75/17 ENU 6486

Noise Symptom - Noises From Plastic Rear Window: Replacing rear window (SY 75/17)

Vehicle Type: 911 GT3 RS (991)

Damaged screen print

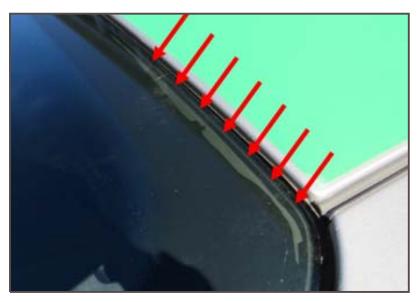
In the event of a customer complaint about noises and if there are signs of damage in the bonding surface area (\Rightarrow Damaged screen print-area arrows-), always check whether the bonding has become detached before doing any other work:

- To do this, press lightly against the window all around the edge of the rear window from inside the vehicle using two fingers.
- If you feel the rear window lifting off in the bonding area (⇒ Damaged screen print -area arrows-), the bonding has become detached.

In the event of a customer complaint about noises, the area can also be sprayed with leak-locating spray/soapy water from outside and then blasted with compressed air from inside the vehicle. If bubbles form, the bonding has also become detached.

\Rightarrow The rear window must be replaced, see Workshop Manual \Rightarrow Workshop Manual '648655 Replacing rear window (Coupé)'.
